## Product Change Notice (PCN)

**PCN Number:** PCN-0374346R-01

Product(s) Affected: *CST-931AP*

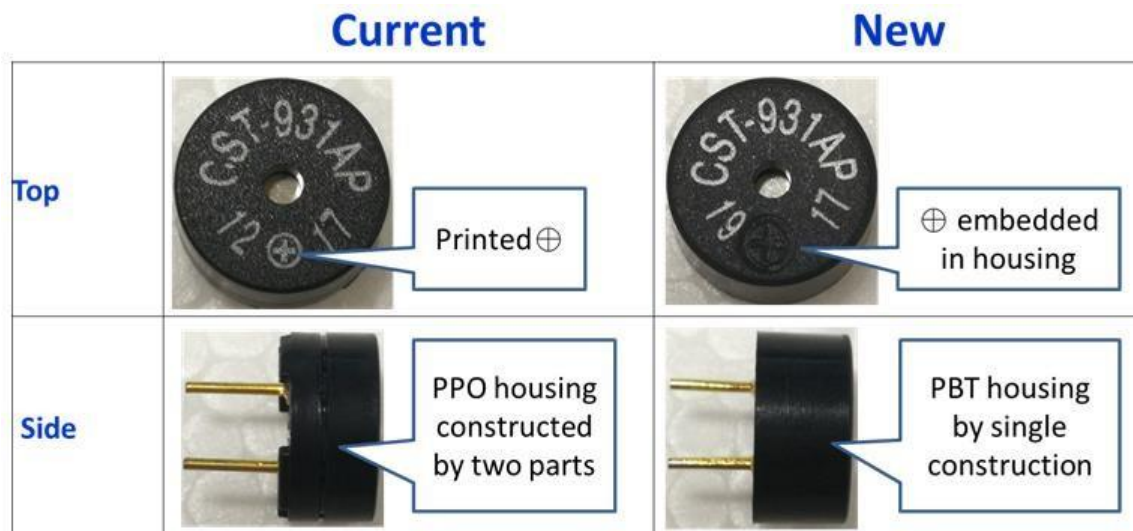
Reason(s) for Change: *To ensure product housing stays uniform and offer a higher temperature rating.*

Description of Change: *Housing changing from two pieces (top+bottom) to one single plastic piece, plastic changing to higher temperature PBT material, positive terminal marking embedded into housing instead of printed.*
